ADDENDUM #1

August 20, 2026

2027 Roof Replacement at
Grizzell Middle School
Dublin City School District Board of Education
8705 Avery Road
Dublin, Ohio 43017

Mays Project #: DOH43-010-03

TAPERED INSULATION PLAN - BASE BID (AND ALTERNATE #1)

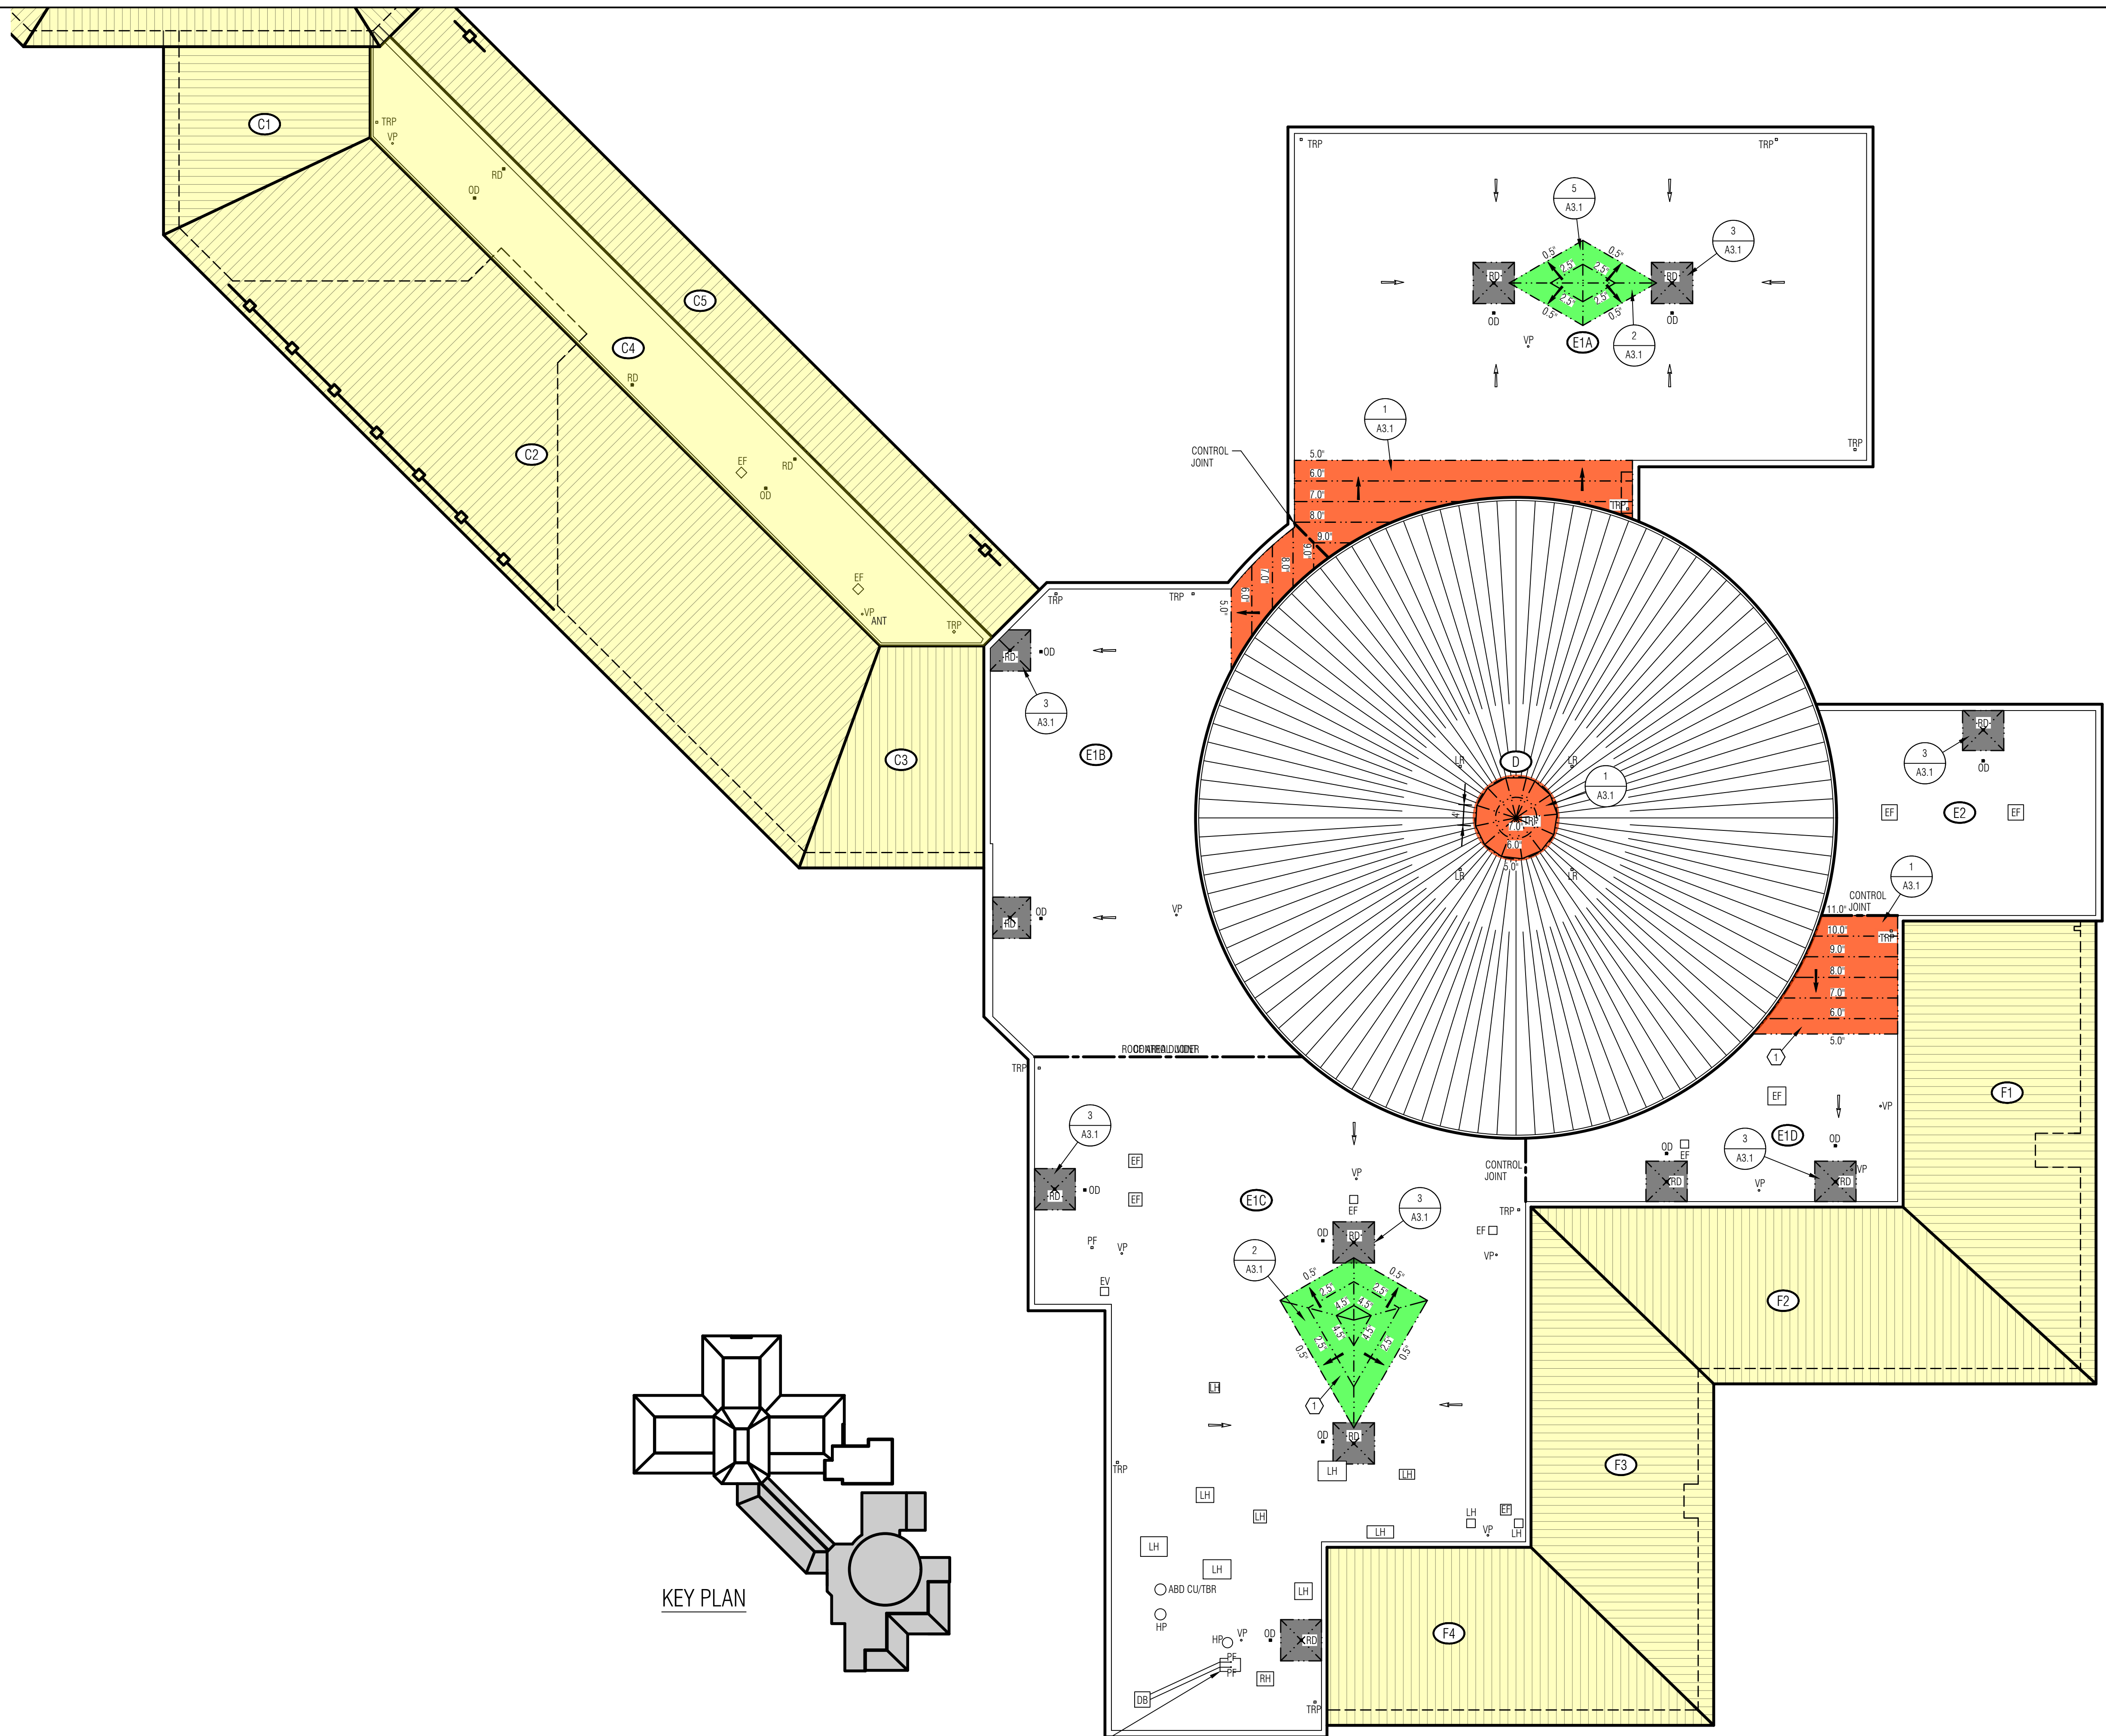
1 CONTRACTOR TO FIELD VERIFY IF TAPERED INSULATION IS REQUIRED IN THIS AREA AFTER THE ROOF HAS BEEN REMOVED. IF THE ROOF DECK IS STRUCTURALLY SLOPED, THIS TAPERED INSULATION CAN BE DELETED.

5 BASE FLASHING AT DOME ROOF DETAIL - BASE BID
A4.2 SCALE: NONE

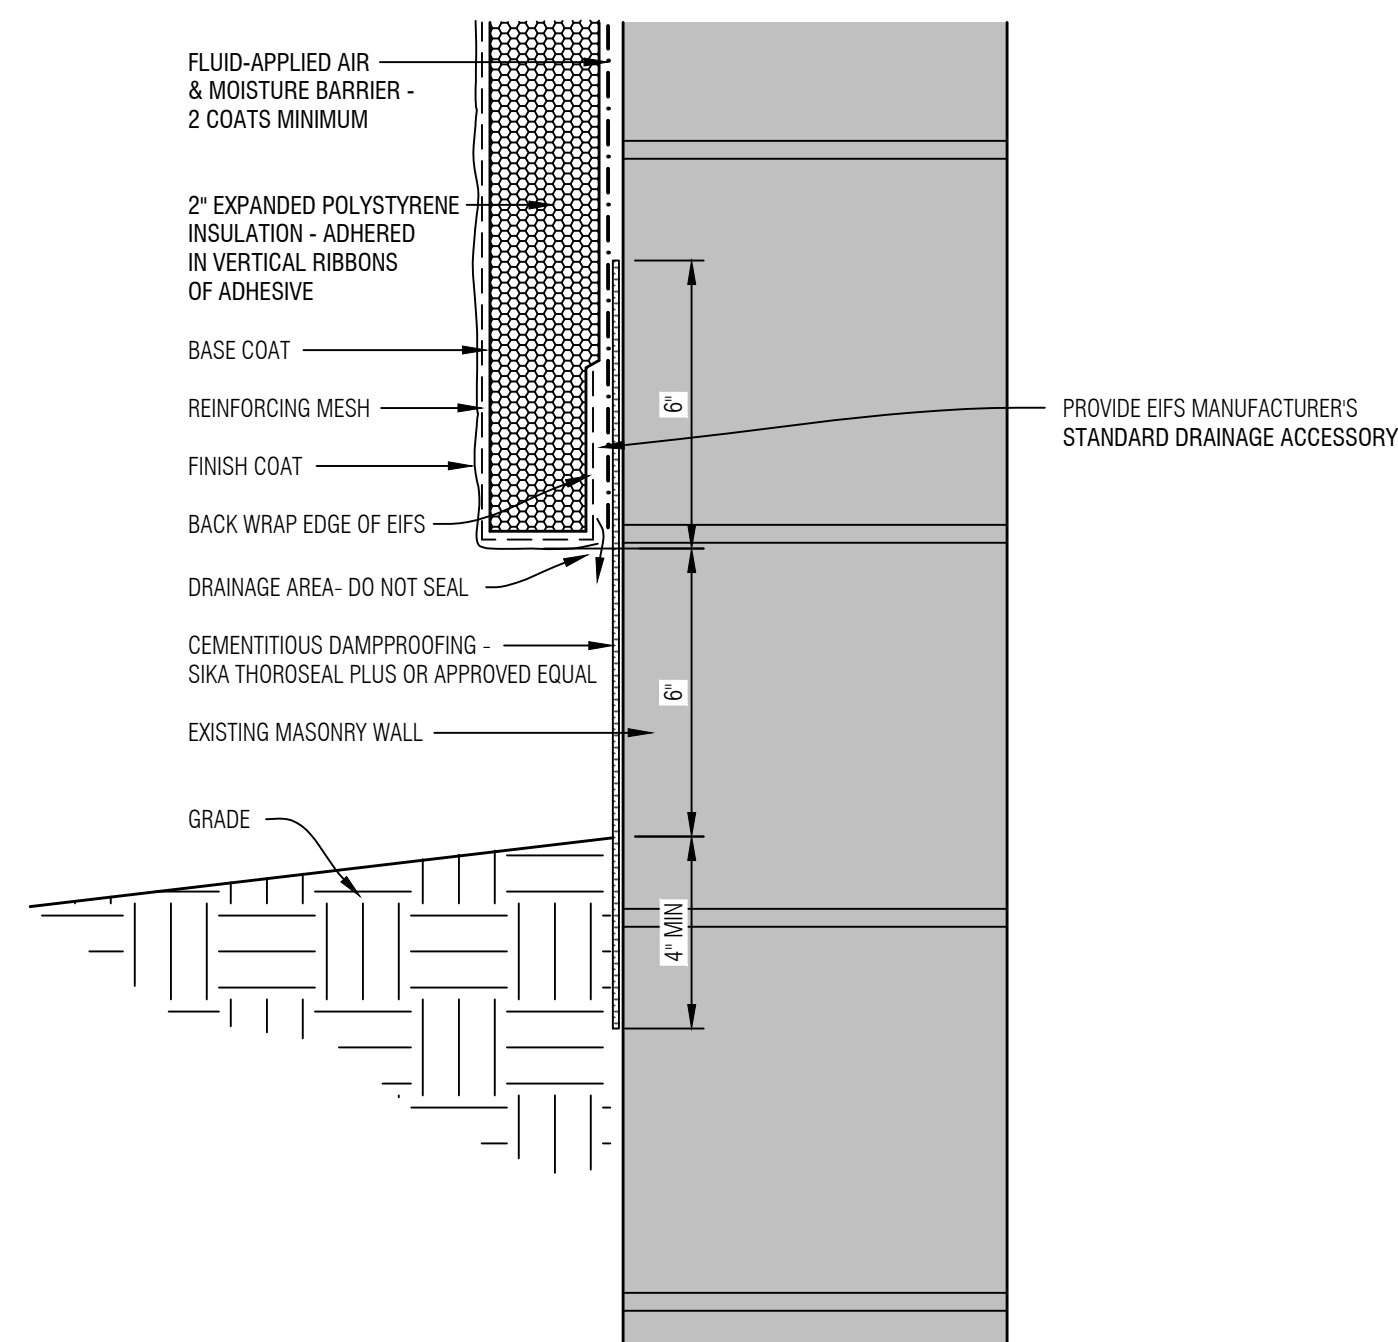
8. Additional project details were added for flashing conditions if only the Base Bid roof area is completed.
9. An updated Plan Holder list has been provided with this addendum.
